ROAD SAFETY AUDIT

PROSPECT AVENUE: PARK ROAD TO NEW PARK AVENUE

November 2025

Exhibit 5: Corridor Recommendations

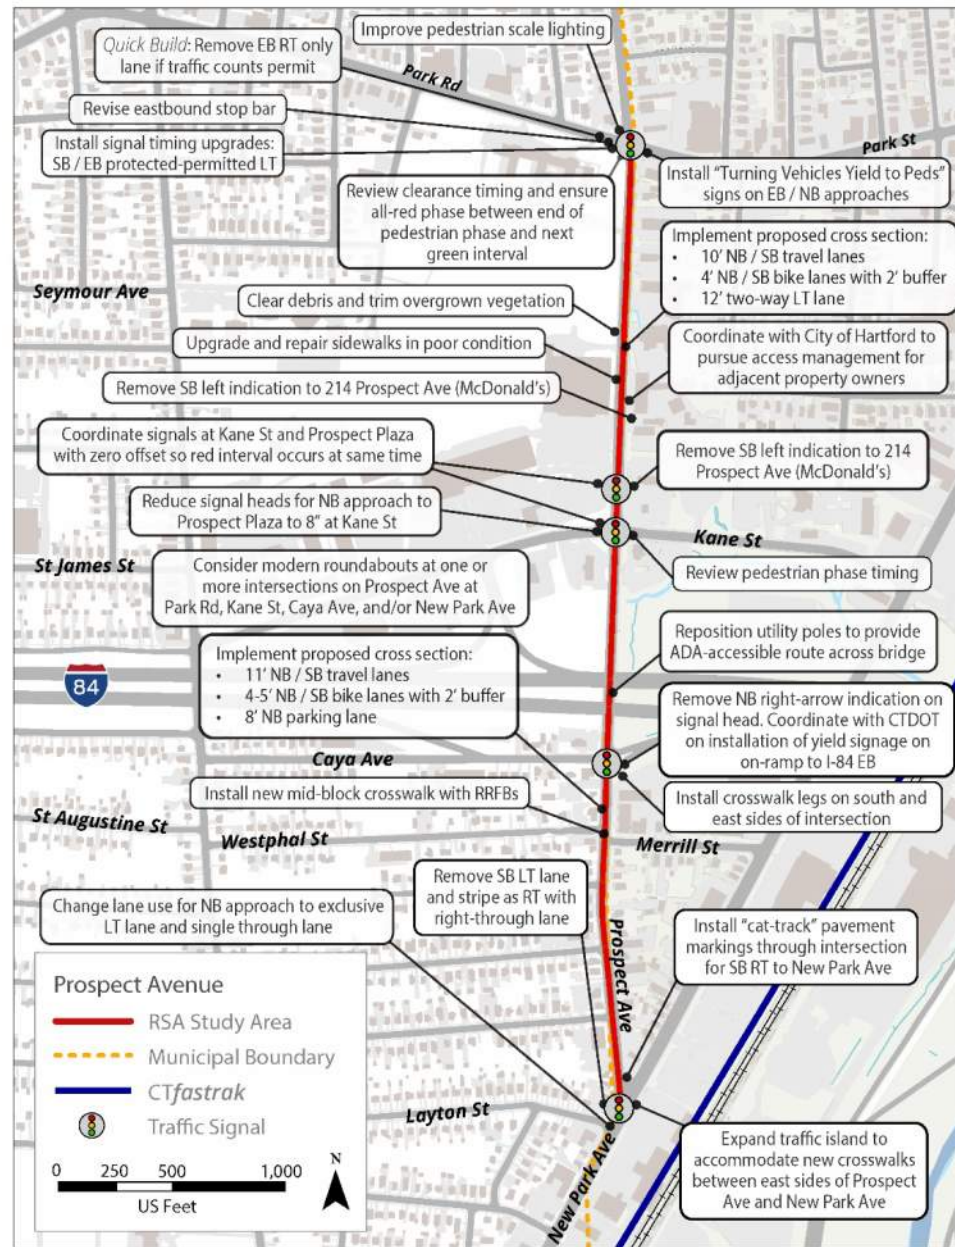
Details on site-specific findings and recommendations are summarized in the subsequent sections. Exhibit 5 provides a summary map of corridor recommendations. Exhibit 6 displays a proposed cross section of Prospect Avenue south of Park Road.

Exhibit 6: Prospect Ave Proposed Cross Section, View North

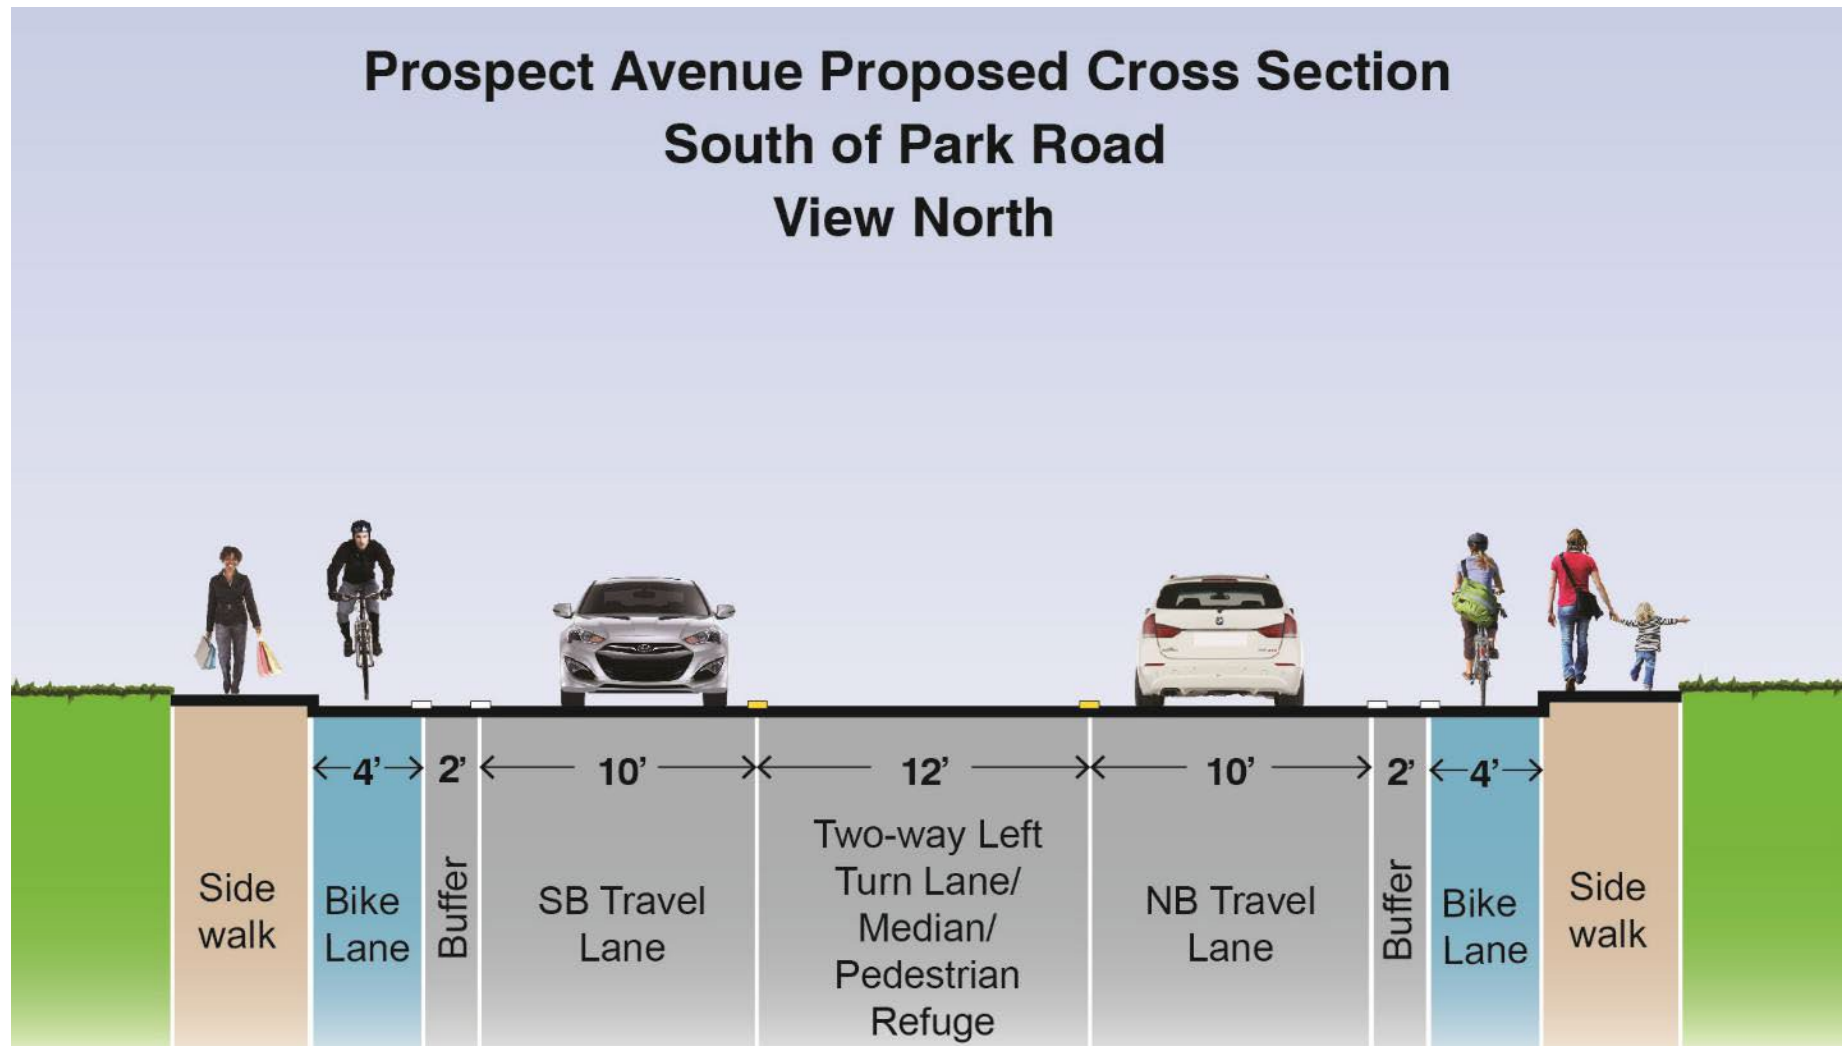
Roundabout feasibility should be further reviewed to ensure compatibility with traffic volumes and geometric design.

- Stripe 11' northbound/southbound travel lanes
- Stripe 4-5' northbound/southbound bike lanes with 2' buffer
- Stripe 8' northbound parking lane

Exhibit 8: Eastbound Left Turn Stop Bar Location (Source: Google Maps, accessed March 10, 2025)

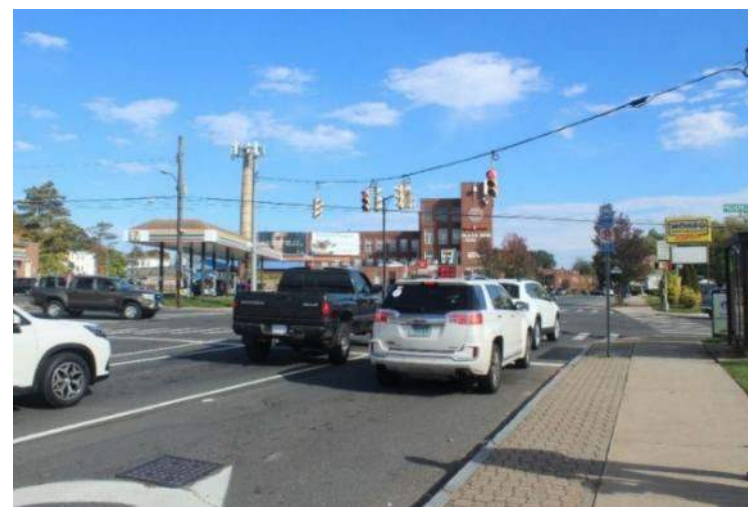
- The eastbound left-turn lane is frequently crossed by turning vehicles westbound onto Park Road because of the location of the stop bar, as shown in Exhibit 8.

- Quick Build: Remove eastbound right-turn only lane if traffic counts permit. Evaluate with quick-build trial.
- Relocate stop bar for eastbound left-turn lane to west to reduce encroachment from turning traffic from Prospect Avenue. Revise eastbound stop bar to discourage encroachment of turning vehicles.
- Review clearance timing and ensure all-red phase between end of pedestrian phase and next green interval.
